Date: Tue, 29 Jun 1999 10:07:05 GMT
From: Martin Fisher <mf@mrao.cam.ac.uk>
Subject: WHT oscillations
To: Clive Jackman <cwmj@ing.iac.es>, Frank Gribbin <fg@ing.iac.es>

After discussions with Frank followed by examining the the log files that have been taken and checking on gear correction issues in the TCS I have come to the following tentative conclusions.

Fig. 4.12 Azimuth gear train

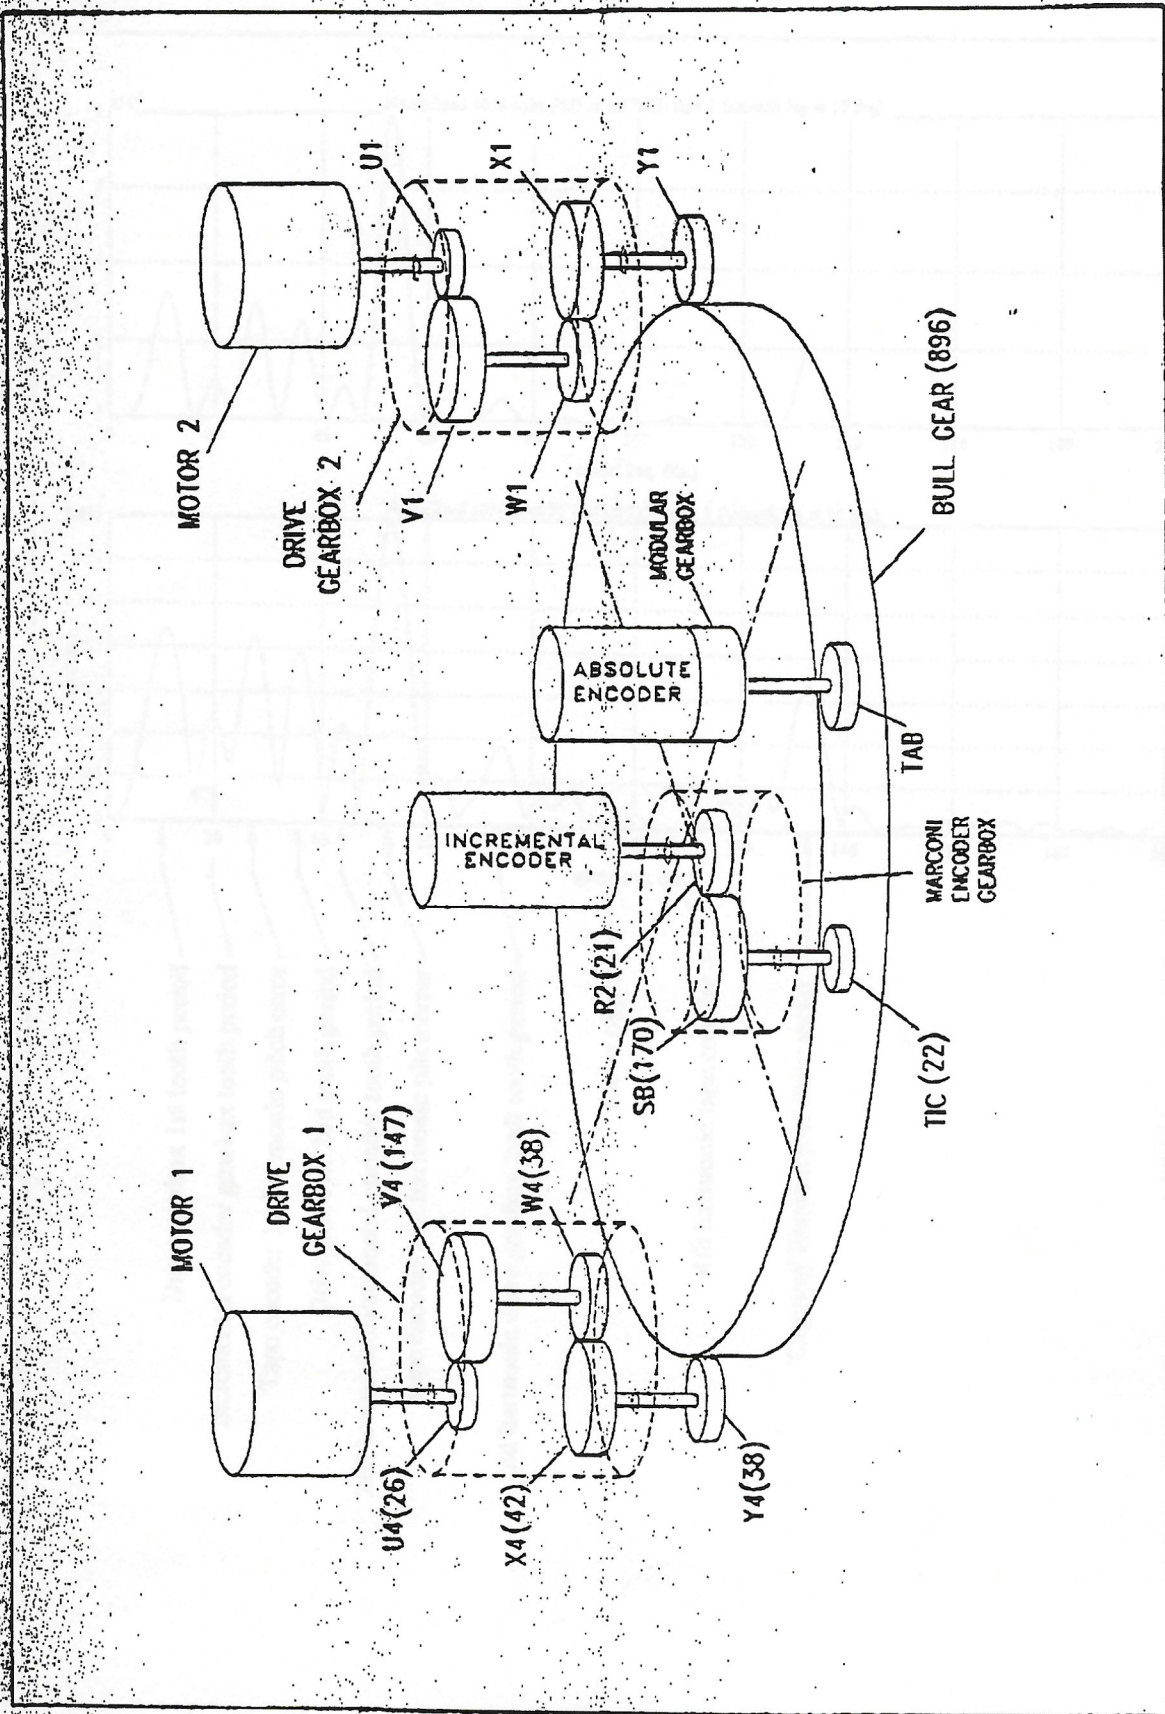
Pages 71 to 73 of my Inductosyn Tape Report (a copy of this is in the library out there) gives a diagram of all the gearing, a typical power spectrum of all the disturbances due to gearing and motor/tacho features and a table of periods/frequencies associated with these components. I will fax a copy of these pages to Mavi but they may not come out so good.
